CK 685

REQ'D.	ITEM	PART NUMBER	DESCRIPTION	SYMBOL
PALMER LIST OF MATERIAL				
MATERIAL			THE TECHNICAL MATERIEL CORP. MAMARONECK, NEW YORK	
FINISH			TITLE DIAGRAM, SCHEMATIC, RECEIVER CONVERTER TTRR-3 8-16 MC	
UNLESS OTHERWISE SPECIFIED DIMENSIONS ARE IN INCHES AND INCLUDE CHEMICALLY APPLIED OR PLATED FINISHES		DRAWN C. Palmer	DATE 11-22-63	FINAL APPROVAL BP
DECIMALS .X ± .05 .XX ± .01 .XXX ± .005		FRACTIONS ± 1/64 ANGLES ± 0° 30'		DATE 1/31/64
TOLERANCES			MECH. DES. W.A. PALMER	DATE
			DATE	DATE
			CK-685	
			SHEET	REV. LTR.

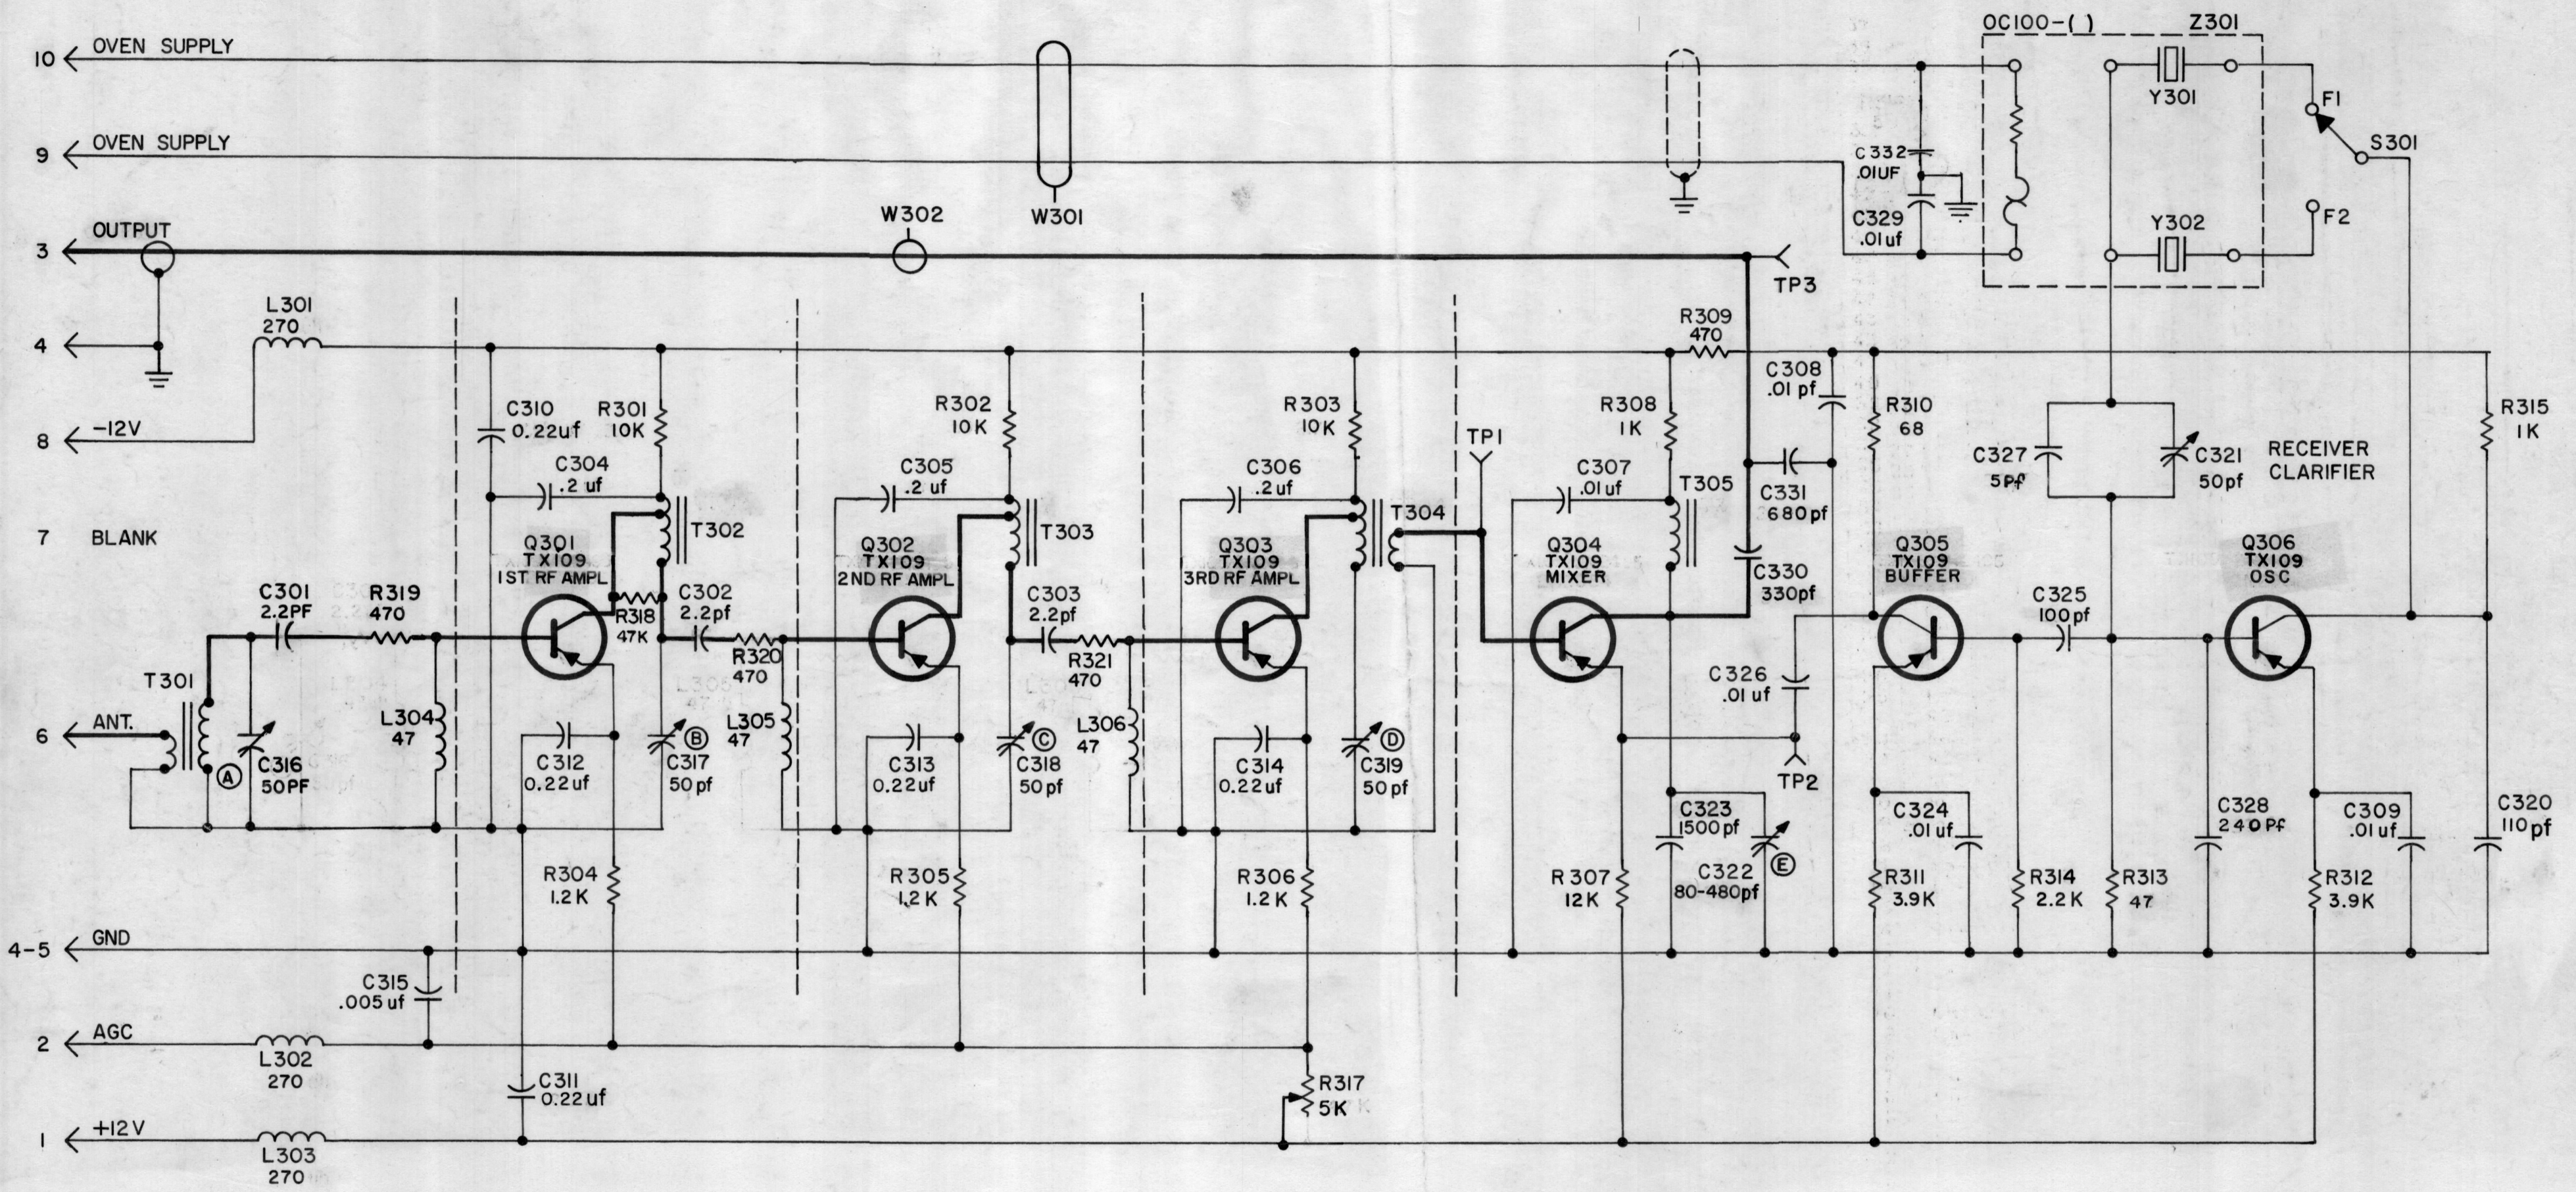
REVISIONS						
SYM	DESCRIPTION	DATE	E.M.N. NO.	DRAFT	CHKD	APPD
G	ALL 2N2495 WERE 2N2496	1/2/65	15082	R.V.V.		
H	R301 WAS 39K, R302 WAS 3.3K, R303 WAS 2.7K, C331 WAS 2000PF	6-30-64	16473		QCB	
J	ADD R318 TO 321. CHG'D CHART FR R317 TO R321	10/6/66	16997	RME		
K	C304 TO C306 WERE .01UF	12-23-66	17680	RME		
L	Q301 TO Q306 WERE TX109/2N2084 R317 WAS 4.7K FIX. RES.	2-24-67	17838	RME

REVISIONS							
ZONE	SYM	DESCRIPTION	DATE	E.M.N. NO.	DRAFT	CHKD	APPD
D6	A	ADDED LINE CONNECTING C312 TO C311	5/5/64	11345	A.M.		
#	B	C311, 13#14 WERE .2uf, C325 WAS 20pf C310 WAS .1uf, C312 WAS 2uf	6/17/64	11590	A.M.		
ALL ZONES	C	SYM. W301, W302, Z301 ADDED TP2 WAS TP3 & TP3 WAS TP2, C320 WAS 110uF	9.14.64	12340	AB		
	D	R307, VAL. WAS 10K; TX109 ADD. TO Q301; TX109 ADD. TO Q302, 303, 304, 305, & 306.	1-26-65	13363	R.L.		
	E	R316 DELETED, C332 .01UF, ADDED, C327 WAS 20PF, C328 WAS 520PF, R313 WAS 15.	7/2/65	14302	R.V.V.		
	F	ALL 2N2496 WERE 2N2084 OR 2N2495	10/4/65	14937	R.V.V.
